CERTIFICATE OF APPROPRIATENESS

Property: 1139 Peddie Street, Lot 11, Block 108, North Norhill Subdivision. The property includes a historic 1,092 square foot, one-story wood frame single-family residence and detached garage situated on a 5,000 square foot (50' x 100') corner lot.

Proposal: Project Type – Construct a rear one-story addition to an existing one-story residence.

Recommendation: Partial Approval:

EAST SIDE ELEVATION

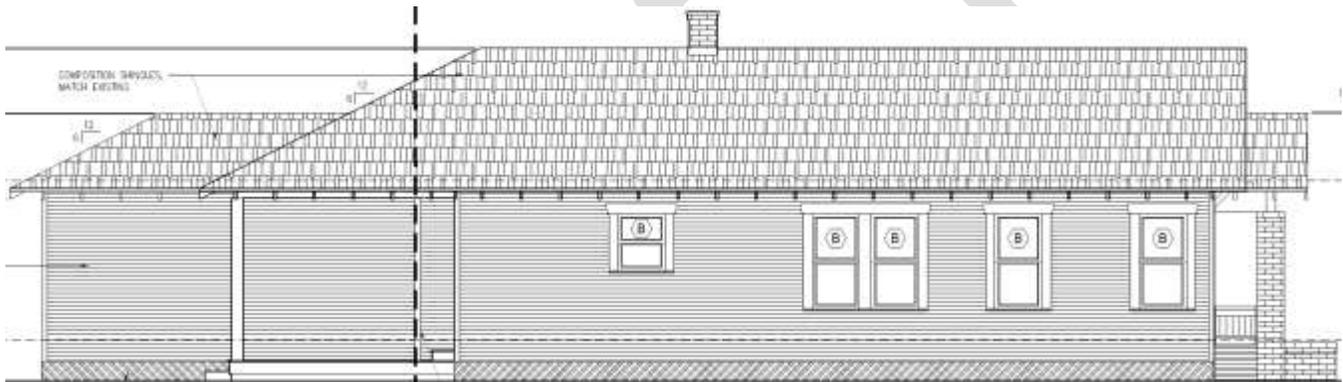
Denial of the splitting and relocation of an original pair of 1-over-1 sash windows on the east elevation.

<i>The splitting and relocation of the original pair of 1-over-1 sash windows on the east elevation alters the fenestration pattern on the east elevation and requires that new openings be created to accommodate the new window locations which results in the loss of significant historical material.</i> |

<i>The splitting and relocation of the original pair of 1-over-1 sash windows on the east elevation alters the fenestration pattern of the 1928 Bungalow. The relocation of the two original windows results in the loss of significant historical material as a result of the new window openings on the east elevation.</i> |

<i>The splitting and relocation of the original pair of 1-over-1 sash windows on the east elevation alters the fenestration pattern on the east elevation and requires that new openings be created to accommodate the new window locations which results in the loss of significant historical material.</i> |
